Lot 81 Summer View Farms
2315 SW Serena Place
Lee's Summit, MO, 64082
Midwest Lumber

Foundation\Floor Joists\J2-16_ O_C_(i7573) (Joist)

BC CALC® Member Report

Repair is Required

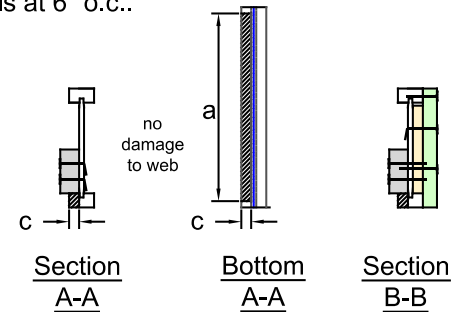
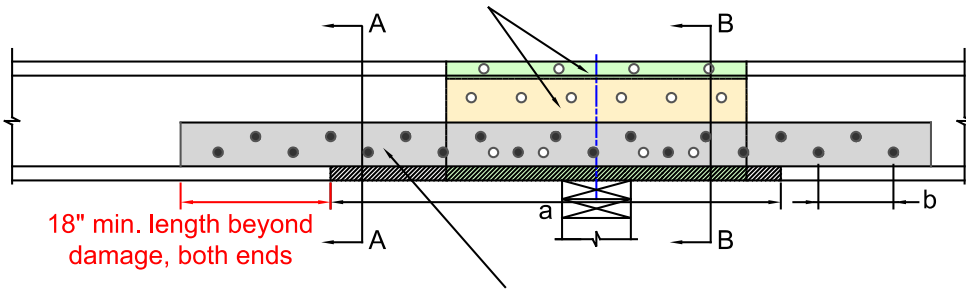
Repair is Required

Required Repair: Jack up /shore up I-joist before repair installation.

Apply construction adhesive to cover all contact surfaces. **Backer:** Install 3/4" - 7/8" APA Rated Sheathing x (clear web depth - 1/4") x 2'-0" min. length backer tight-fit to the top of the bottom flange centered at the bearing opposite the damaged side. **Reinforcer:** Install 1 1/8" APA Rated Rim Board x 9 1/2" depth x 2'-0" min. length, tight-fit to the top of the bearing, centered at the bearing opposite the damaged side. **Through web:** fasten with 2 staggered rows 10d nails at 4" o.c., clinched downward where possible. **Through top flange only:** fasten with 1 row 8d nails at 6" o.c..

Apply construction adhesive to cover all contact surfaces. Min. 2x4 x (1'-6" min. beyond both ends of bottom flange damage) #2 & Btr. SPF & Btr. KD-19, or VERSA-LAM® LVL reinforcement damaged flange side of web, tight-fit to top of bottom flange

- 1) Center backer and reinforcer at the center of the bearing support.
- 2) Center 2x4 at the center of the flange damage and extend 1'-6" min. beyond the ends of the damage.
